REMARKS

FIG. 2

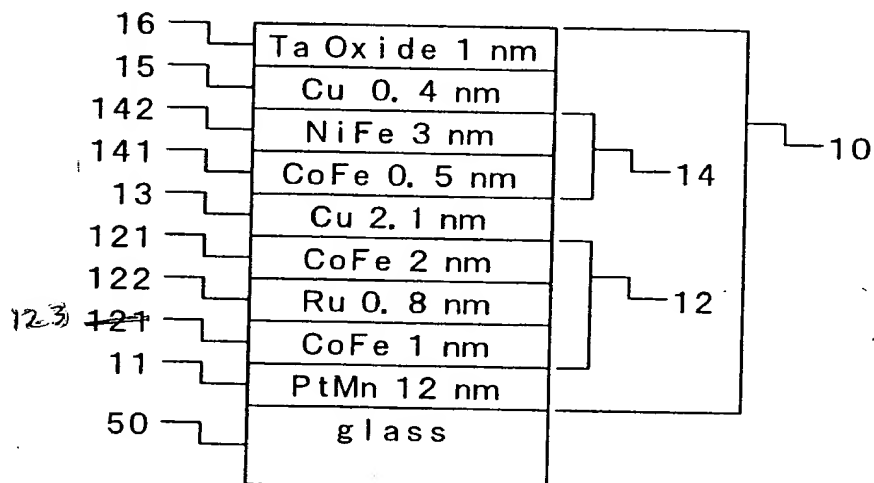
With regard to the objection to the drawings, submitted herewith are corrected drawings of Figures 2 and 13 wherein the second reference numeral 121 of Fig. 2 has been changed to 123 and the writing gap 37 in Fig. 13 has been indicated. With respect to reference numeral 17 appearing in Fig. 4, the specification has been amended refer to the Ta layer 17. Thus, applicants submit that the drawing objections should now be overcome and submitted herewith are corrected drawings of Figs. 2 and 13 and acceptance of the corrected drawings is respectfully requested.
